DSC-H1

SERVICE MANUAL

CORRECTION-1

- Correction of printed wiring boards and schematic diagrams
- Correction of repair parts list

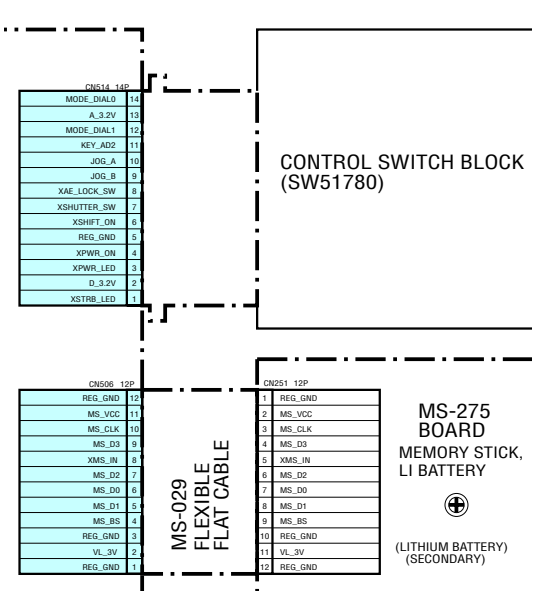
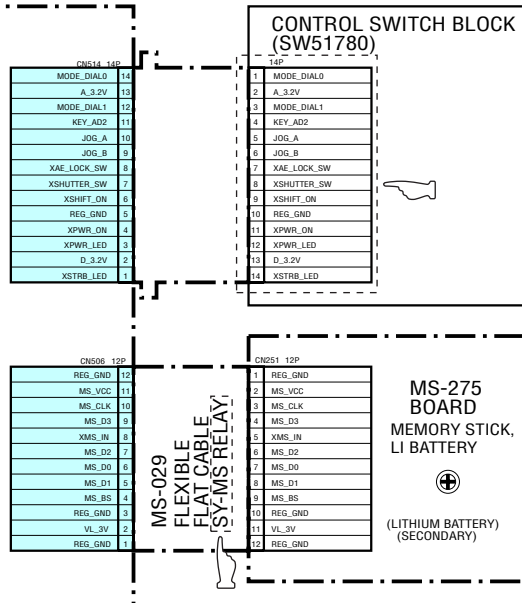
Page	INCORRECT	CORRECT
4-1	**4-1. FRAME SCHEMATIC DIAGRAM** SY-127 BOARD (1/11) LENS DRIVE (2/11) CAMERA A/D CONV. TIMING GENERATOR (3/11) CAMERA DSP,SYSTEM CONTROL (4/11) 256Mbit SDRAM,FLASH MEMORY (5/11) SUPER AND FLASH MEMORY (6/11) A/V AND,USB/AV JACK,SP,MIC (7/11) PANEL DRIVE (8/11) STEADY SHOT CONTROL	SY-127 BOARD (1/11) LENS DRIVE (2/11) CAMERA A/D CONV. TIMING GENERATOR (3/11) CAMERA DSP,SYSTEM CONTROL (4/11) 256Mbit SDRAM,FLASH MEMORY (5/11) SUPER AND FLASH MEMORY (6/11) A/V AMP,USB/AV JACK,SP,MIC (7/11) PANEL DRIVE (8/11) STEADY SHOT CONTROL
4-2

Page	INCORRECT
4-25 to 4-26	**4-2. SCHEMATIC DIAGRAMS** **SY-127 BOARD (3/11)**

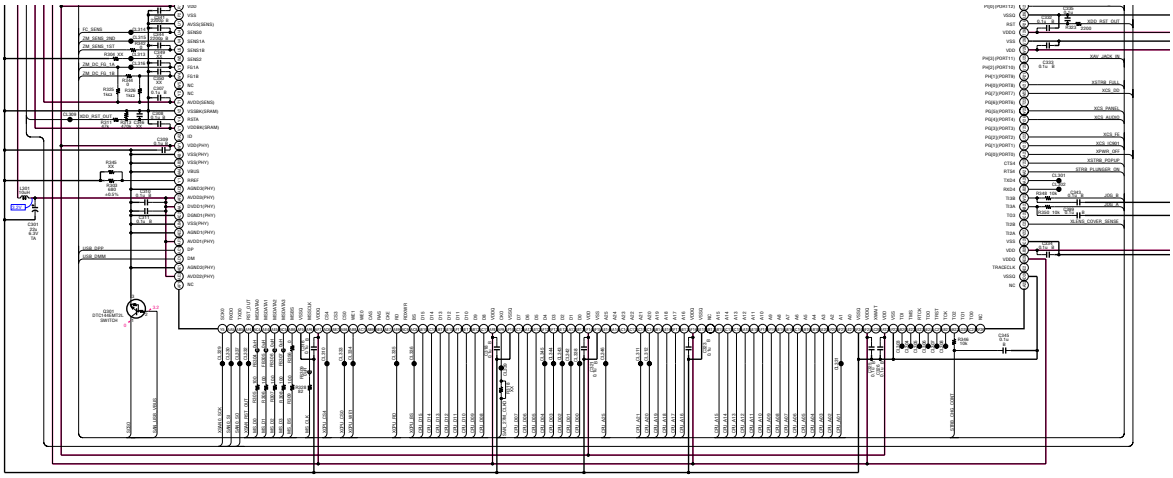
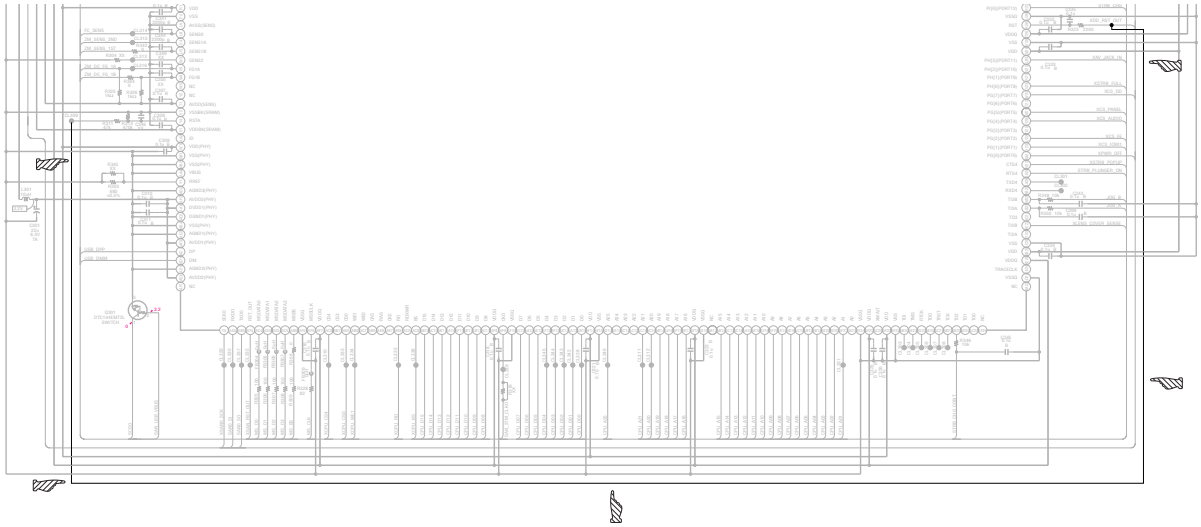
: Corrected portion

CORRECT
